EVALUATION OF THE WIPP PROJECT'S COMPLIANCE
WITH THE EPA RADIATION PROTECTION STANDARDS
FOR DISPOSAL OF TRANSURANIC WASTE

Environmental Evaluation Group
7007 Wyoming Blvd., NE, Suite F-2
Albuquerque, New Mexico 87109

March 1998

Fig. 21. Permeability vs. Porosity Model With BRAGFLO for Left) Marker Bed 139 and Right) Marker Beds a and b.

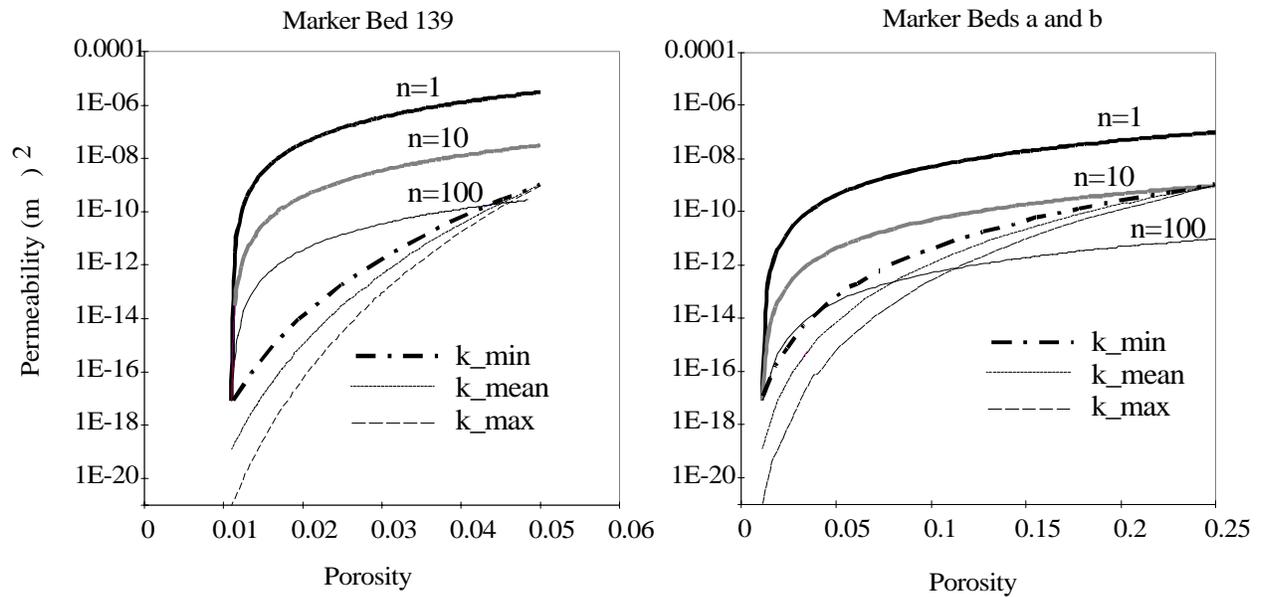
Our conclusion is that the conceptual model BRAGFLO for anhydrite fracturing may be a valid description for pore pressures less than 1 MPa below lithostatic but a cubic law formulation of the permeability-porosity relationship is valid above this threshold. As demonstrated by Freeze et al. (1995), the BRAGFLO parameters can not be set to reasonably represent this region. Figure 21 is an updated version of Figure 2 of Freeze et al. (1995). The BRAGFLO model is based on CCA parameters for marker bed 139 and anhydrite layers A and B respectively. The figure shows the permeability-porosity relationship of the BRAGFLO model to a cubic law based model for multiple fractures. Our concern is that the BRAGFLO model under-represents permeability by more than four orders of magnitude for small porosity increases. By setting the model parameters to match a cubic law fracture model at large porosity, a large error may have been introduced for small porosity changes.

The BRAGFLO model has not been tested against either laboratory or hydrofracing experiments or other standard fracture modeling codes. This comparison should be made before the model can be accepted as valid.

Fig. 24. Fractional Discharge Of Uranium Across The LWB Within 100,000 Years, With Blowout Section Of 10,000 Years. Reproduced from Rucker (1998).

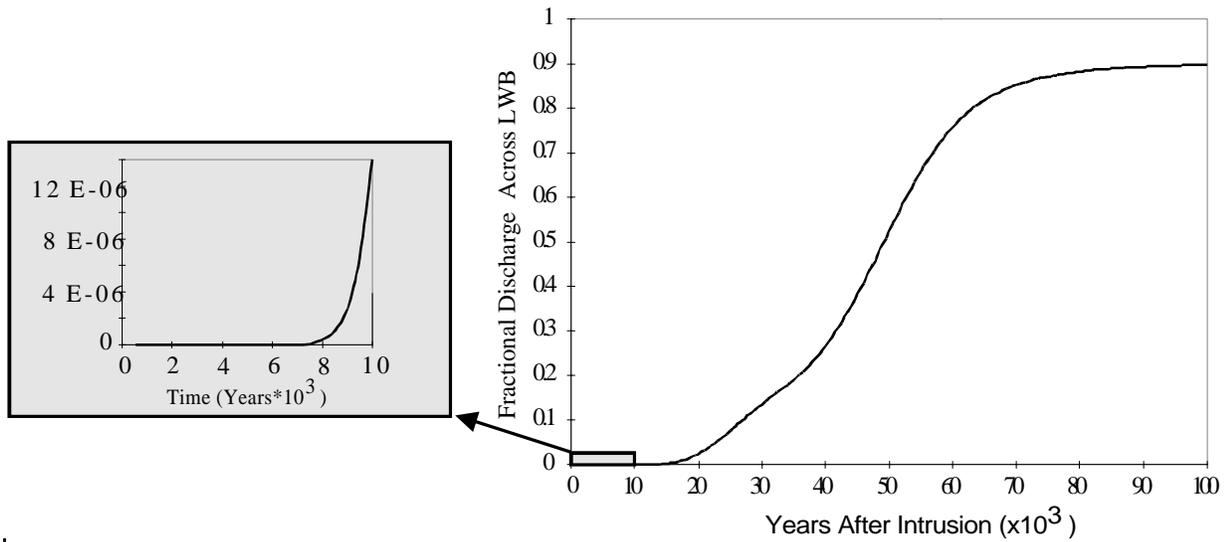
During discussions with our consultants after the July 30 meeting, it was pointed out that if the calculations for release were continued beyond the 10,000 year period, release to the accessible environment will be seen. Rucker (1998) also shows that a significant fraction of actinide mass will cross the LWB beyond the 10,000 regulatory time frame. Figure 24 (reproduced from Rucker, 1998) shows the fractional discharge of Uranium with a retardation coefficient of 2.0

crossing the LWB. The figure demonstrates that very little mass that enters the Culebra crosses the LWB during the initial 10,000 years and almost the entire nuclide mass fraction will cross the LWB by 70,000 years post intrusion. The EEG recommends that the performance assessment calculations be extended beyond 10,000 years to determine long-term system performance.
